REPORT

12th meeting of GRRF Informal Working Group on Automatically Commanded Steering Function

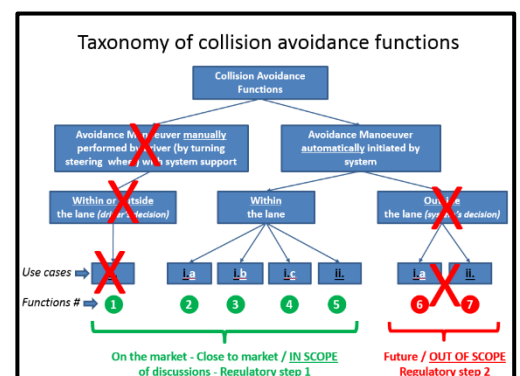
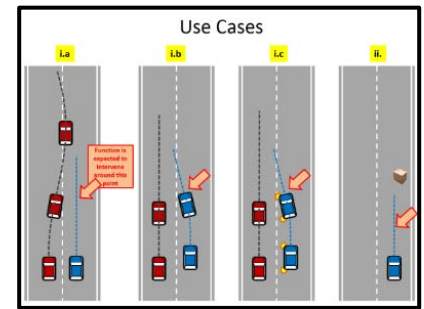
(C-J): The CPs think, that minimum requirements are necessary:

- a) minimum range
- b) minimum torque to override
- c) always combined with CSF or CAT B1?
- d) limitation of the intervention time

(OICA): Agreed to a), b) and d). c) should be optional.

Finally the group agreed to amend slide 4 as shown here:

ESF should only be dedicated to a “Avoidance Manoeuvre automatically initiated by system” within the lane and not initiated/controlled by the driver.

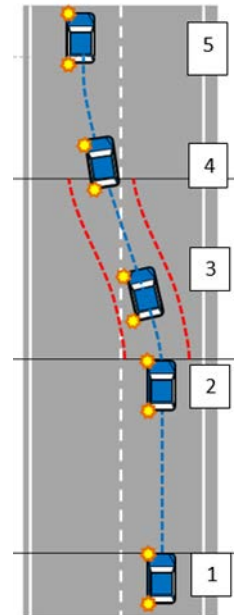
2.4.13.1 How long shall a direction indicator lamps been activated?

Most of the CPs agreed, that the direction indicator may be deactivated at point 4. (see sketch right)
